Interactive comment on “Hydrologic and geochemical modeling of a karstic Mediterranean watershed” by N. P. Nikolaidis et al.

Received and published: 28 February 2012

Fig. 1. Geology of Koiliaris River Basin.

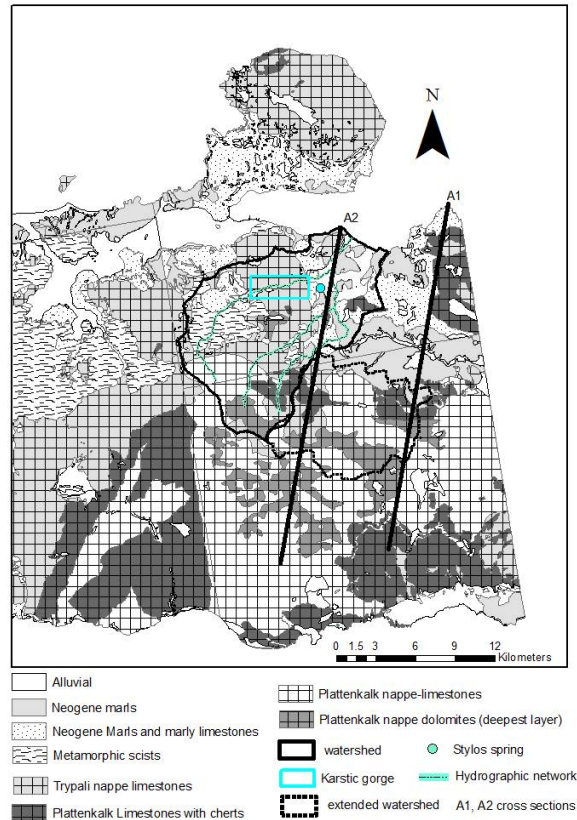
* Figures 1, which is supposed to present the test site, does not indicate the location of the test site; it also has no scale, no north arrow, no legend, etc. Where are all the springs and gorges that you are talking about? What is the structure and geometry of the aquifer system, etc.?

* Figure 1 is unacceptable: No location, no scale, no north arrow, no legend, no information on geology, etc. Furthermore, your model cannot estimate the extended karst area.

The karstic system of the White Mountains is comprised of an autochthonous geotectonic unit, Plattenkalk and two allochthonous units. the Trypali limestones and the metamorphic schists (Figure 1). The Plattenkalk nappe consists of layers of dolomites, limestones and marbles and limestone and cherts with intense bedding (in the lower boundary of metamorphism). The Trypali nappe is highly karstified and has overthrust the Plattenkalk nappe. The metamorphic schists overthrust both the Plattenkalk and Trypali units mainly in the western part of the White Mountains. Neogene sediments (marls and marly limestones) have been deposited at the lower elevations of the basin over the autochthonous formation. Finally, alluvial sediments are found near the river corridor mostly in lower elevations. Figure 1 presents the geology of the area of Koiliaris River watershed and Figure 2 presents two geologic cross sections depicting the stacking of the nappes and the existing faults.

Figure 1 will be revised to present the watershed and extended karst area on a geologic map with the faults included. Scale, direction and legend will also be included. The structure of the aquifer system is discussed in general comment #1.

Fig. 2. Geologic cross sections of Koiliaris River Basin.

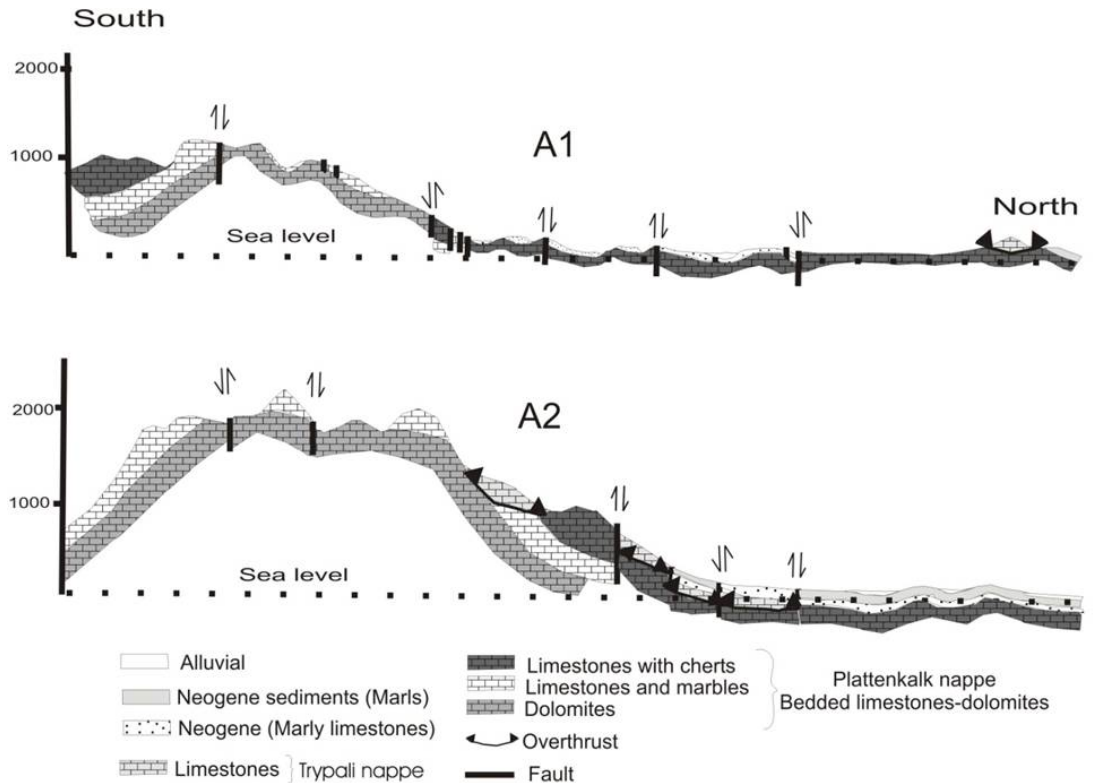
* The hydrologic behavior of karst aquifer systems can only be understood on the basis of a thorough hydrogeological analysis and a valid conceptual model. However, this article only presents some verbal description of geology, but no geological or hydrogeological maps and sections, and no conceptual hydrogeological model of the aquifer system.

* Section 2, page 6: This is a poor and incomplete description of the geological setting. What is missing here is a geological map, geological cross sections and/or block diagrams, etc. What means "has an intense geomorphology"? Did you do tracer tests to delineate the catchment?

A significant discussion of the hydrogeologic setting of the area has been presented in a previous publication (Moraetis et al., 2010) in the Journal of Hydrology. A brief review of the system has been presented in the manuscript on page 5 and the conceptual model (as implemented in the SWAT model) is presented in section 3. We agree with the reviewer that a brief review presentation of the setting, functioning and structure of the karst will improve the overall readability of the manuscript. The geologic map with the faults and a cross section can also be presented. The manuscript will be revised as follows:

The stratigraphy of Crete has been formed by one dipping north and one south that meet at the north-south divide (approximately at 2000 m elevation) as well as east-west trending zones (Papanikolaou and Vassilakis, 2010). The Plattenkalk autochthonous formation in the watershed has significant east-west normal faults dipping north. At the eastern part of the White Mountains there is increased exhumation of the autochthonous nappes, while in the western part, there is stacking of allochthonous nappes that overthrust the north-west dipping of Plattenkalk. Along the Plattenkalk dipping a series of normal faults influence the creation of neogene sedimentary basins (Fassoulas, 1999).

The karst system is characterized by very fast infiltration and direct connection to the conduits below. There is a significant number of sinkholes with long downward shafts, caves and a deep conduit system (Gourgouthakas cave -1205m, Liontari cave -1100m-Moraetis et al. 2010). The karst system discharges in a series of permanent springs, Stylos springs at elevation +17 m AMSL and an intermittent spring, Anavreti at elevation +24 m AMSL. Both springs then feed Koiliaris River. The springs have an average discharge of 154 million m³/yr (2007-2010) with very intense fluctuation between winter and summer flows. The total recharge area of the springs extend beyond the boundaries of Koiliaris River Basin to the south-east of the watershed boundary (Moraetis et al., 2010). The area of the extended karst is depicted in Figure 1 and was determined based on geologic and fault analysis (Figure 2). The cross sections of the extended karst area identify a major fault in a northeast-southwest direction (located at the boundary of the karst and neogene deposits) which together with dipping of the nappes direct the water towards the Koiliaris River Basin. Considering the dipping of Plattenkalk nappes towards north-west in relation to normal faulting, the dolomites (lower part of the stacking sequence) which are less karstified come in contact with the Plattenkalk nappes (upper part - more karstified limestones with cherts) at lower elevation (Figure 2) directing the water to the springs.
